Service Bulletin: SB-14 Rev A

SUBJECT – PART 178-47 (FLOAT BRACKET) FOR MSA UPDRAFT MODEL CARBURETORS.

FIGURE 1

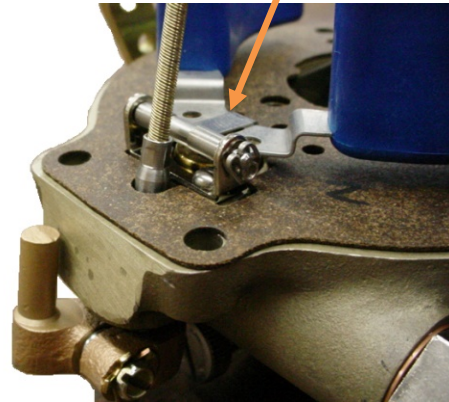
2. **Reason:** To advise the industry that bracket 178-47 is no longer used and has been removed from production float assemblies 30-862 and 30-864 as of 2010.

3. **Background:** Before 2005, float assemblies utilized a wire clip 29-194 to secure the float needle to the float assembly. After that time, a stamped clip 29-184 (See Illustration) was used, rendering the 178-47 see figure 1 float bracket superfluous.

4. **Compliance:** **None** – Note: Existing stock float assemblies with brackets may be used until exhausted.
5. **Voiding of Warranty and Waiver of Liability:** Operation of a carburetor in which other than genuine Volare approved parts are installed **voids any otherwise applicable warranty and constitutes a complete and total waiver** to the extent permitted by law of any and all rights the owner, operator and/or service facility or repairer may have had to hold Volare responsible or liable for the malfunction or failure of such an aviation carburetor. The owner/operator and/or service facility or repairer that makes an unauthorized repair or modification to a Volare carburetor shall bear the sole responsibility and full liability for any **damages of whatever nature, injury, or death** arising from any malfunction or failure of such a non-compliant aviation carburetor.

FIGURE 2

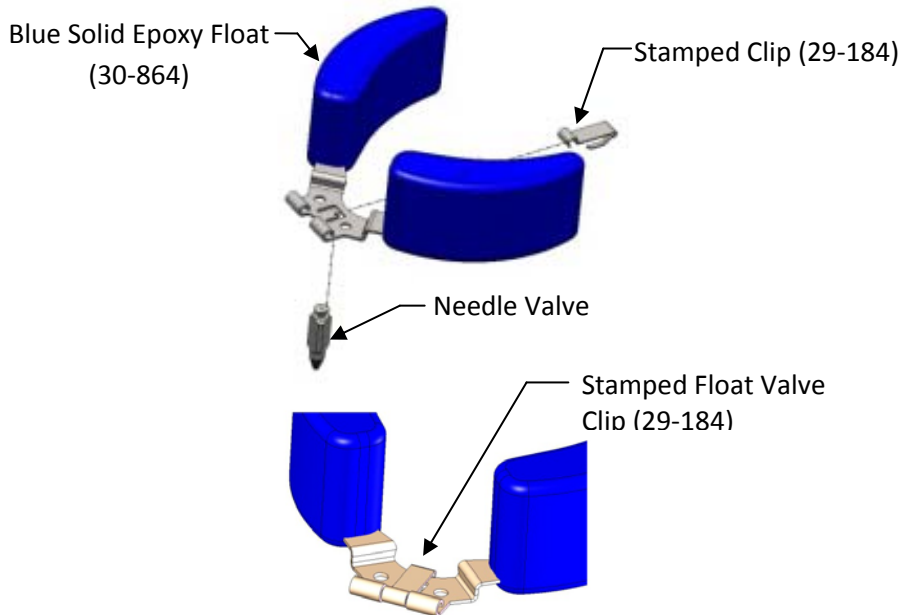
Float Bracket Omitted
